DEPLOY/RETRIEVE STORAGE SYSTEM (DRSS)

COMPONENT LEVEL DEFINITION AND TRADEOFF ANALYSIS

-ERRATA SHEETS-
DRSS PHASE 1A FINAL REPORT

The following errata sheets contain the Gould, CID response to preliminary NUSC review comments of the DRSS Phase 1A Final Report. There are no changes required to either the conclusions and/or recommendations as a result of the corrections listed herein. The Appendices have not been reviewed.

Figure 3.1.2.2(f). HP Matrix Envelope Chart

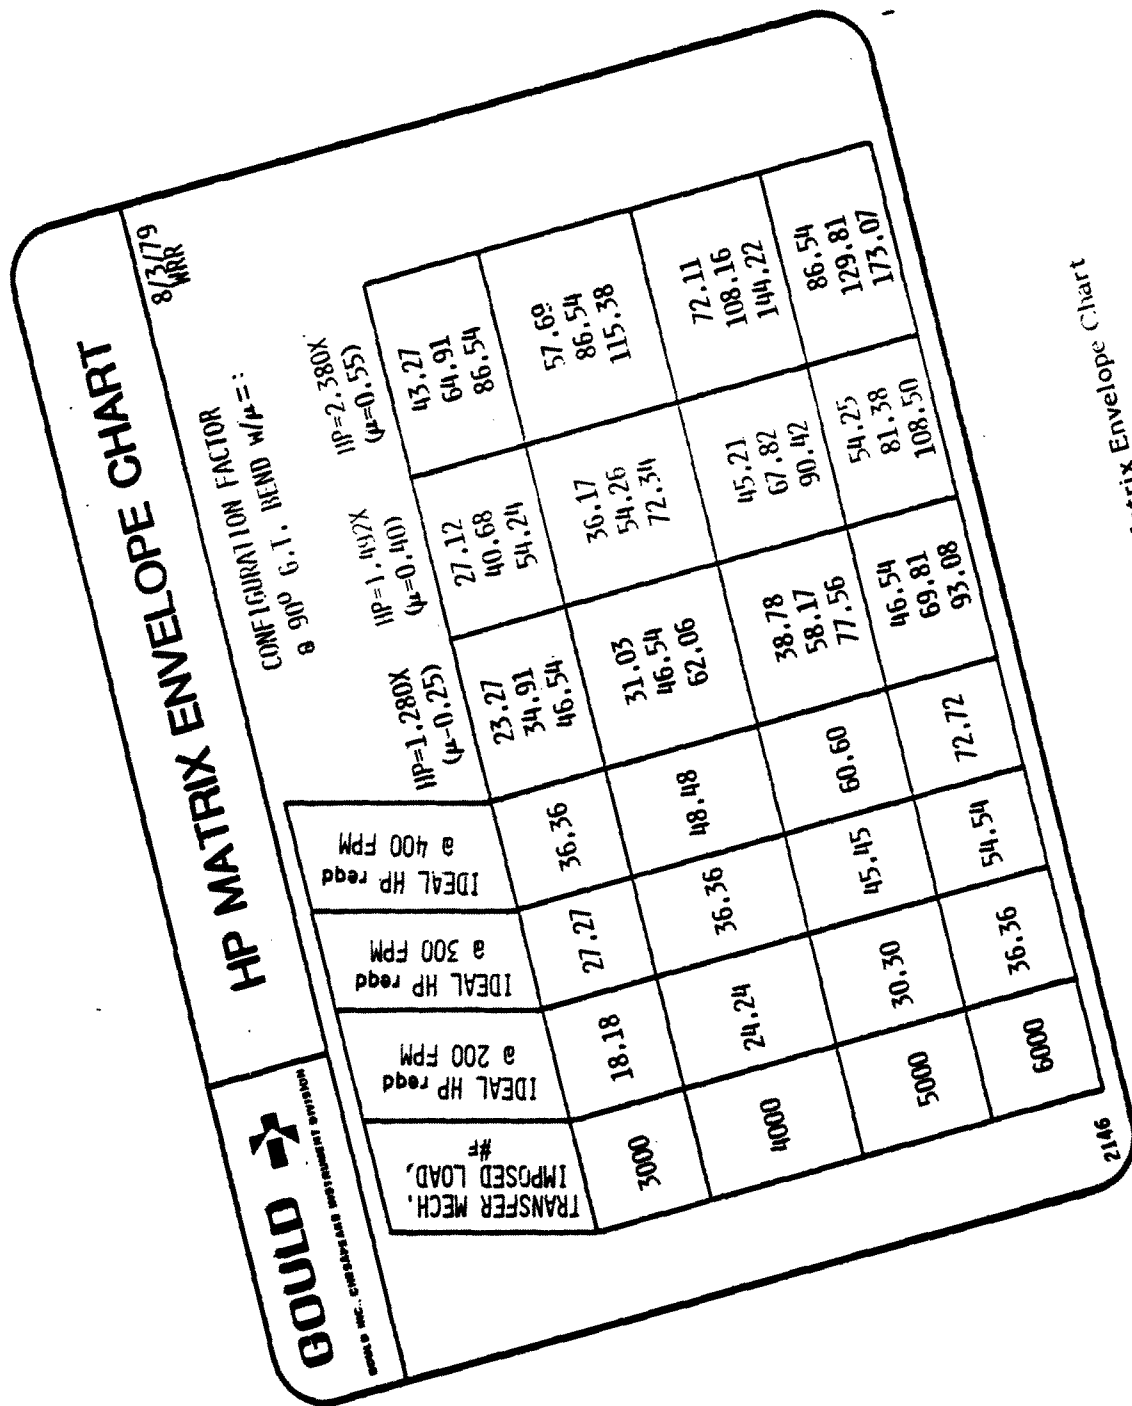
- p 60 Figure 3.1.2.2(f) Change the following:

HP = 1.481X ($\mu=.25$)	HP = 1.874X ($\mu=.40$)	HP = 2.372X ($\mu=.55$)
26.92	34.07	43.12
40.39	51.10	64.68
53.85	68.14	86.25
35.90	45.43	57.50
53.85	68.14	86.25
71.80	90.85	114.99
44.87	56.78	71.87
67.31	85.17	107.81
89.75	113.56	143.74
53.85	68.14	86.25
80.77	102.21	129.37
107.70	136.28	172.49

Figure 3.1.2.2(g). Two-Speed Operational Mode (5000#_f)

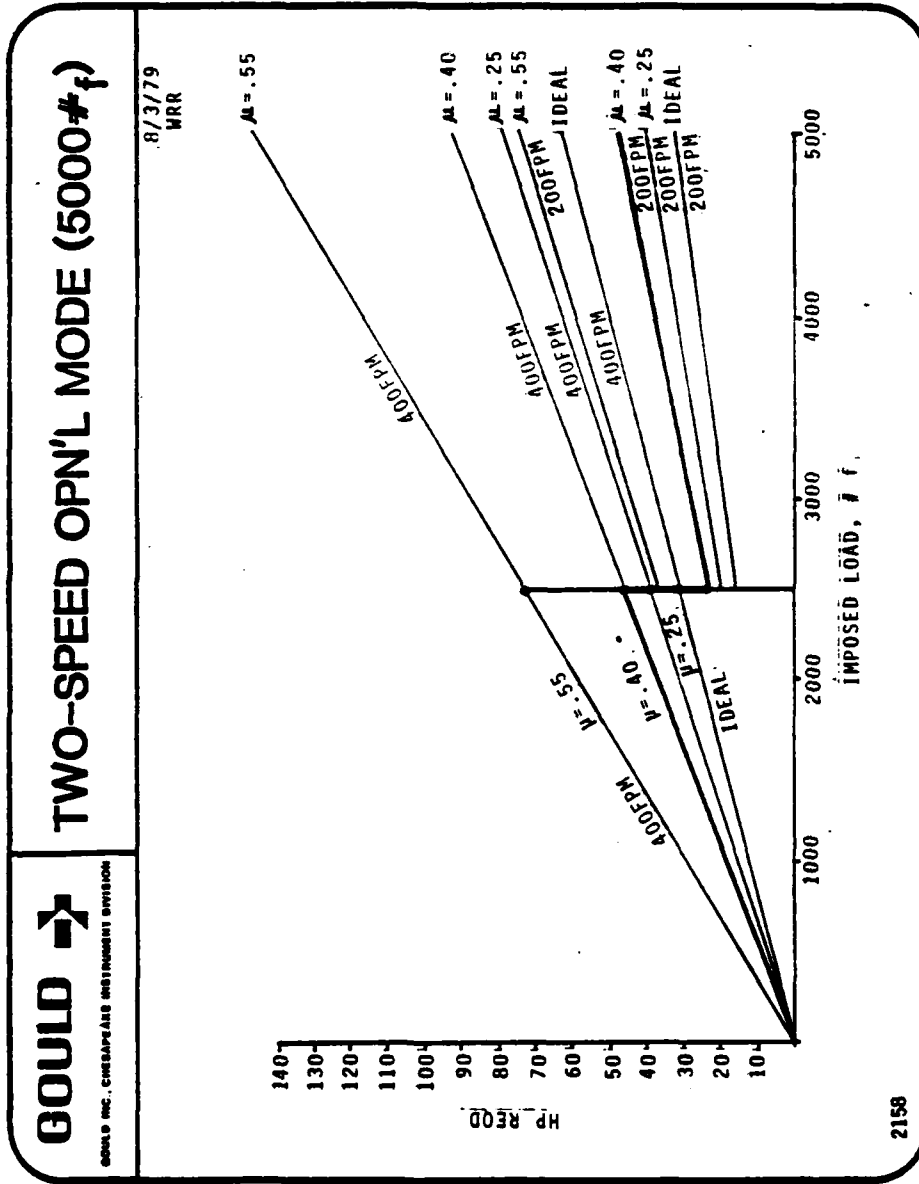
- p 61 -- Figure 3.1.2.2(g) Disregard figure, use new data above.

Figure 3.1.2.2(h). Hydraulic Power Supply Adequacy Analysis

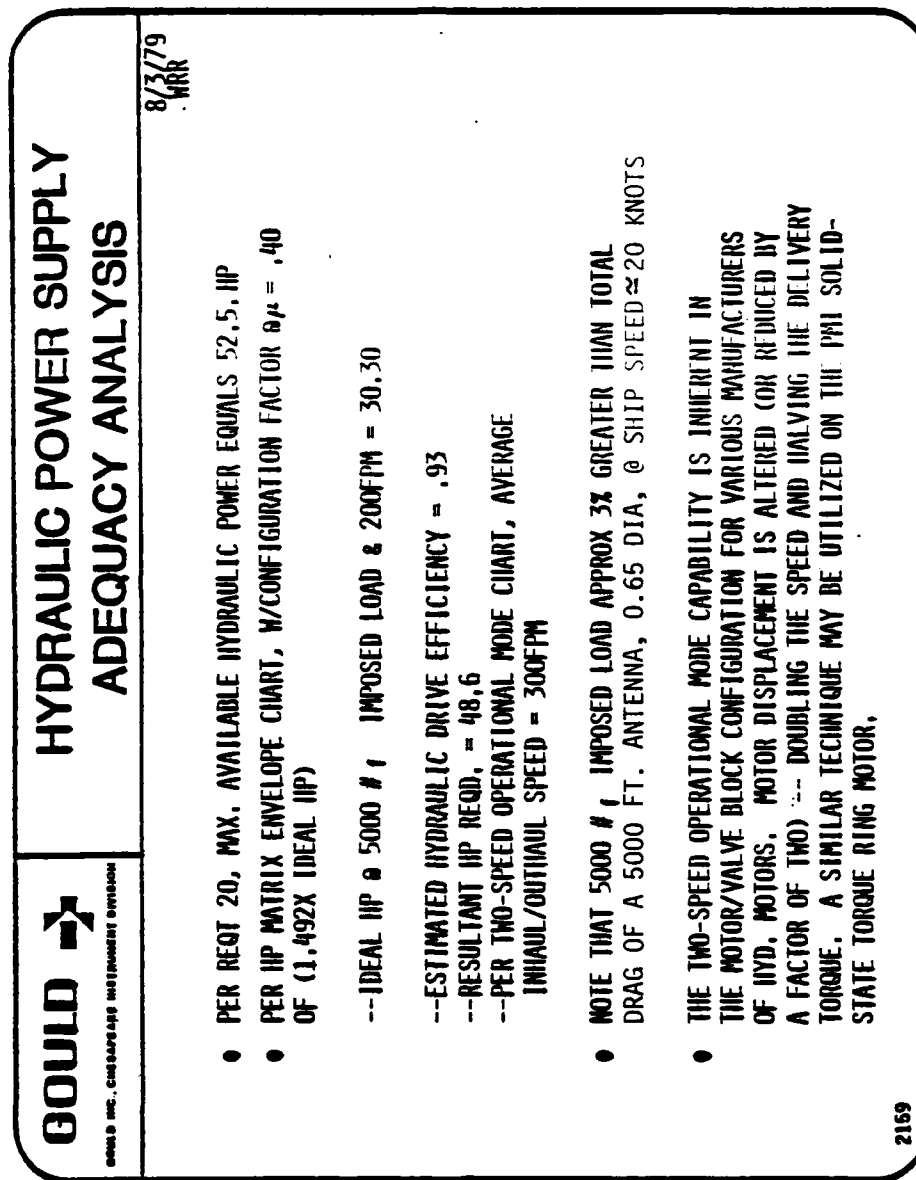
- p 62 -- Figure 3.1.2.2(h) Change the following:

1.492X to 1.874X
5000#f to 4.25#f & 30.30 to 25.00
48.6 HP reqd. to 50.37 HP reqd.
20 knots to 15 knots
1739#f to 1925#f
553#f to 613#f/linear foot

Figure 4.1.5.1. Articulated Bellmouth, Tow/Exit Point

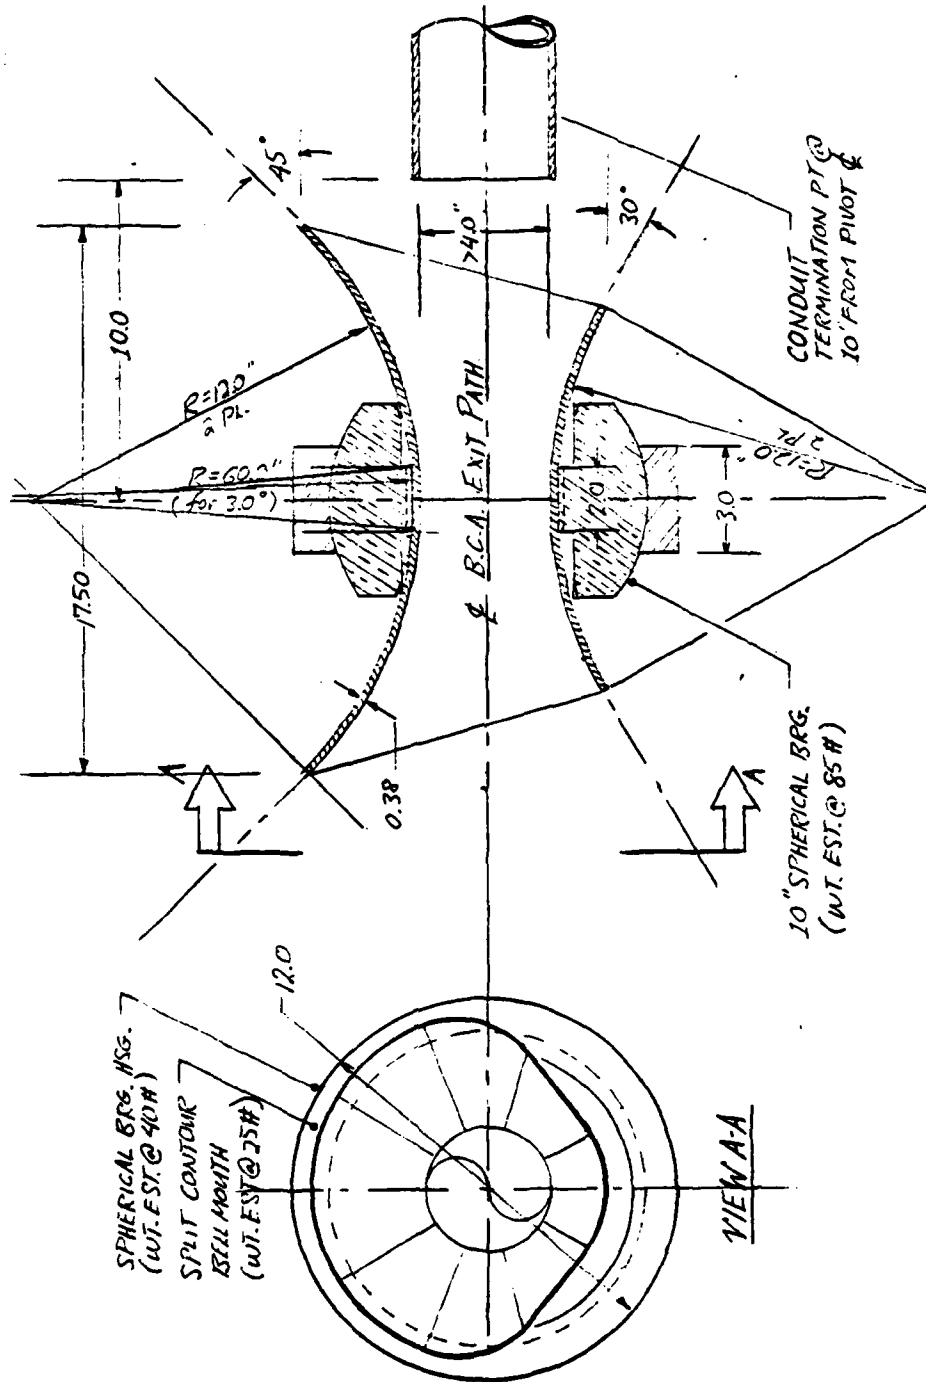
- p 101 -- Figure 4.1.4.1 Does not show method to prevent rotation of the articulated bellmouth?
- Explanation: Rotational forces are very low, with pivoting forces far greater. If rotation cannot be prevented, the contour geometry would have to be uniform. Further definition will be required, although this is not foreseen as a high risk item.
